PRODUCT/PROCESS CHANGE NOTICE (PCN)

PCN #: TB-0609-02 DATE: 06-Oct-2006 Product Affected: SOJ 28L, 32L, 36L Products shipped in tube Date Effective: 06-Jan-2007	MEANS OF DISTINGUISHING CHANGED DEVICES: <input type="checkbox"/> Product Mark <input type="checkbox"/> Back Mark <input type="checkbox"/> Date Code <input checked="" type="checkbox"/> Other Rev. 08 printed on shipping tube
---	---

ATTACHMENT I - PCN #: TB-0609-02

TOLERANCES UNLESS OTHERWISE SPECIFIED		DECIMALS		ANGLE	
.XX ±.25		.XXX ±.13		.XXX ±.13	
APPROVALS		DATE		SCALE	
DRAWN		DATE		N/A	
CHECKED		DATE		SIZE	
TITLE:		STOCK NO.		DRAWING NO.	
PB/PBG 28/32/36		P1-069-000		MSC-3026	
SHIPPING TUBE		DO NOT SCALE DRAWING		SHEET 1 OF 1

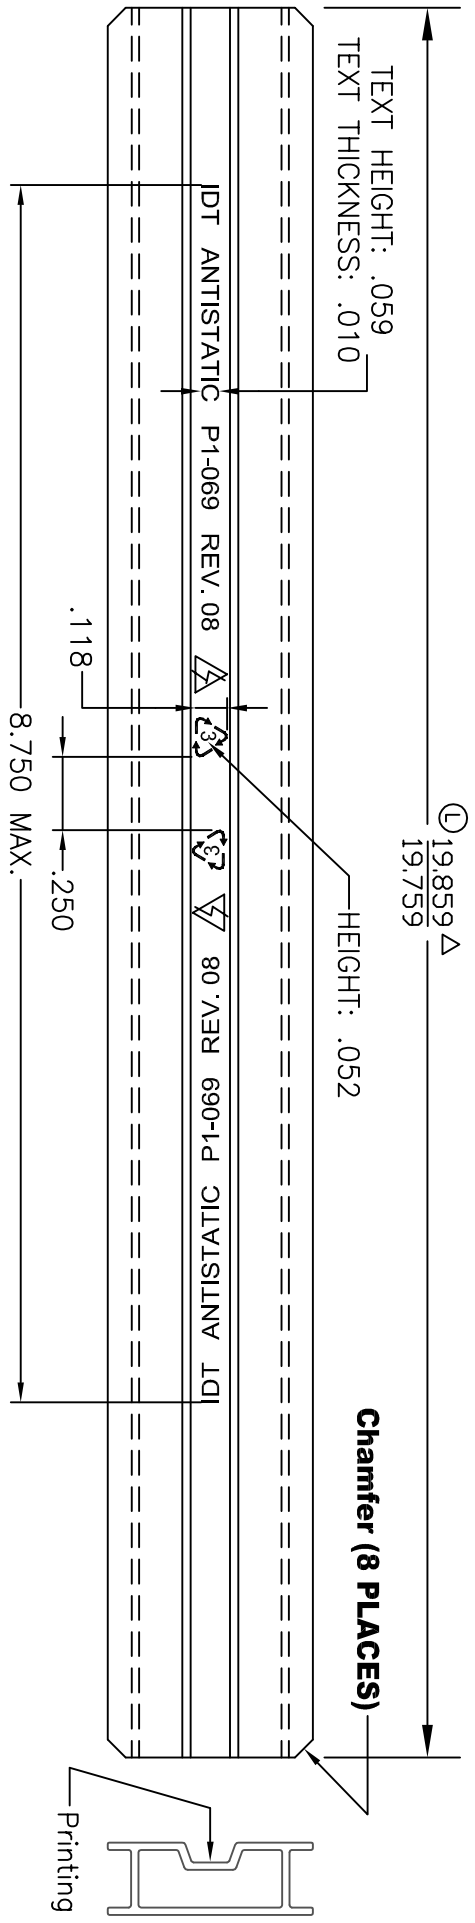
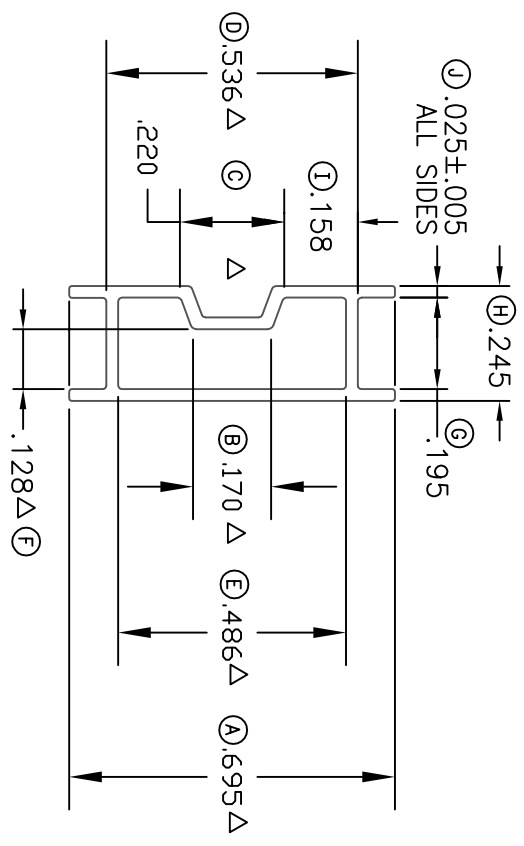
Detail of Change: This notification is to advise our customer that IDT has qualified new shipping tubes for SOJ 28L, 32L, 36L products. The new shipping tubes have an increase in the tube opening height from 0.105 inches to 0.128 inches to provide better protection for packages during assembly, test and backend processes.

* Note: Tube opening height is denoted as dimension 'F' in the tube drawing. See attachment for the drawing.

REVISIONS			
REV	DESCRIPTION	DATE	APPROVED
13	INCLUDED ITW MERITEX AS SUPPLIER	03/11/06	KK Three
14	INCREASE (F) FROM 0.105" TO 0.128"	08/24/06	KK Three

Description	Existing Shipping Tube	New Shipping Tube
Supplier	ITW Meritex	ITW Meritex
Supplier Part Number	O-XT0687 Rev 07	O-XT0687 Rev 08
IDT Part Number	P1-069-000 Rev 07	P1-069-000 Rev 08
Revision Printed on Tube	Rev. 07	Rev. 08
* Tube Opening Height (inches)	0.105	0.128
